Hornsea Project Three - Deadline 9 Response from Natural England Subject:

THE PLANNING ACT 2008 THE INFRASTRUCTURE PLANNING (EXAMINATION PROCEDURE) RULES 2010 HORNSEA PROJECT THREE OFFSHORE WIND FARM

Written Submission for Deadline 9

[ExA Qs F4.1, F4.2, F4.3]

Figure 2. CRM run for Herring gull using parameters provided by Applicant. The per annum collisions for AR 99.4, 99.5 and 99.6 should be 9, 7 and 6 respectively and not 5, 4 and 3 collisions as in the Applicant's version (see Figure 1 above).

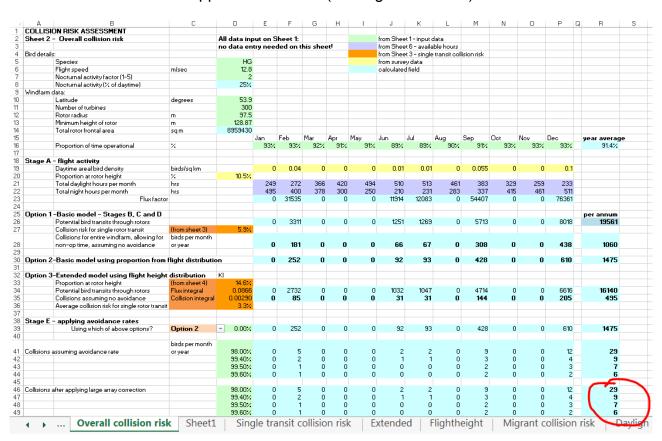
Natural England considers that the Applicant is presenting misleading information by implying that they have presented spreadsheet outputs from the Band Model when in fact they haven't. Natural England has run the Band Model using the figures provided by the Applicant and the per annum collisions are correct in the Band Spreadsheet (see Figure 2 below). Therefore the Applicant must have cut and pasted the per annum total column into the [REP7-043] from another source
